Rezoning Transportation Analysis

Petition Number: 2018-146

General Location Identifier: 19911106

Date	Description
12-19-18	First Review
01-22-19	Second Review (MTH)

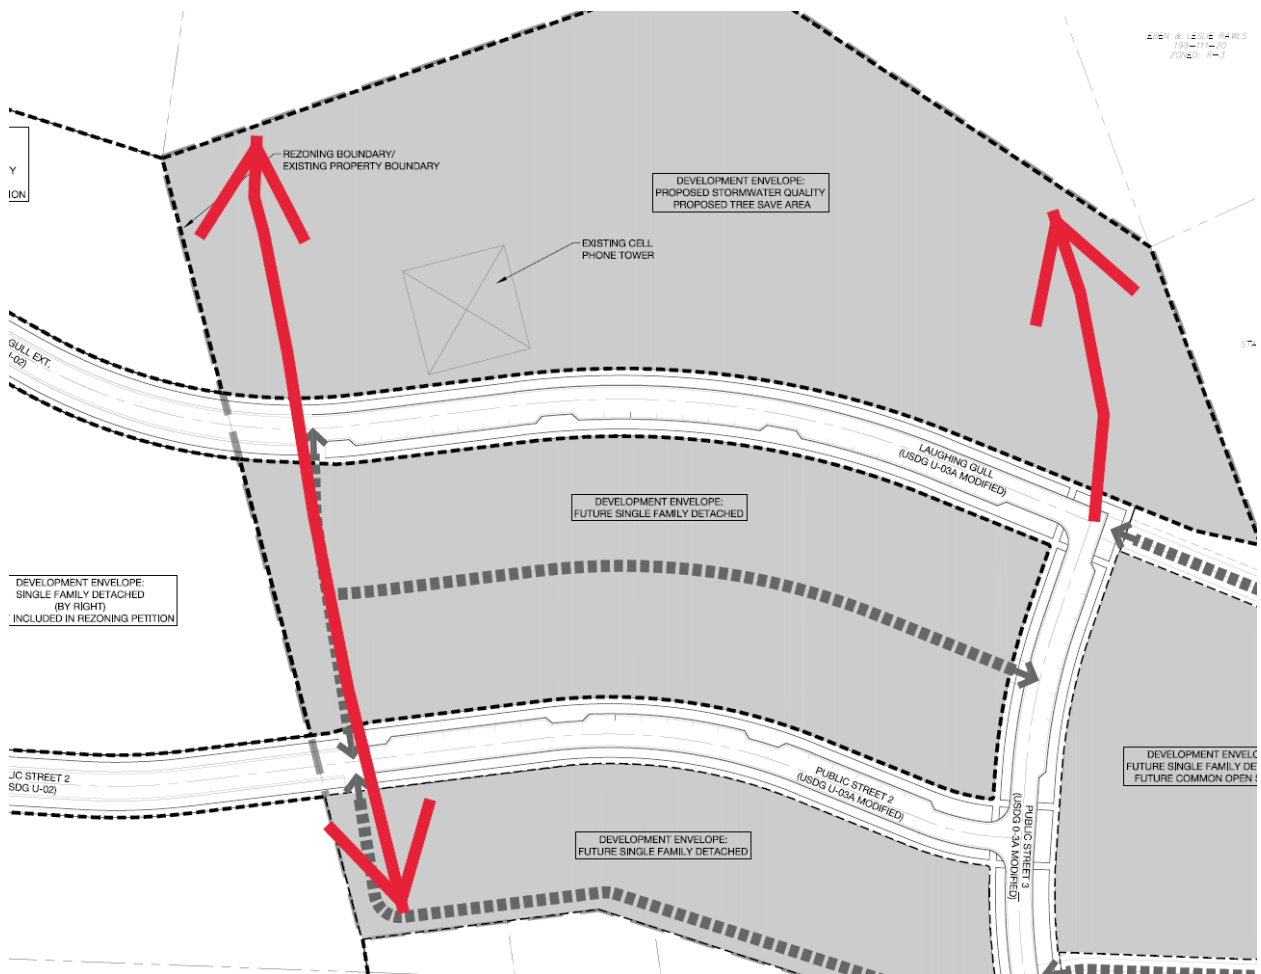
- ~~3. The petitioner should revise the site plan and conditional note(s) to show and commit to 6-foot sidewalk on Shopton Road West along the frontage of parcels 19911103 and 19911106. The front of the sidewalk is located 51 feet from centerline of the road. The site plans needs to label and dimension the sidewalk.~~
4. Shopton Road West has a future right-of-way of 126 feet. The petitioner should revise the site plan and conditional notes to show the dedication of right-of-way, fee simple, of 63 feet from centerline of the road.
5. The petitioner should revise the site plan and conditional note(s) to commit to constructing an East-West "Local Residential Wide" Street.

Technical comment: The petitioner has only shown right-of-way dedication but the street stubs need to be constructed during site development and as required per Subdivision Ordinance. Update site plan and conditional notes.
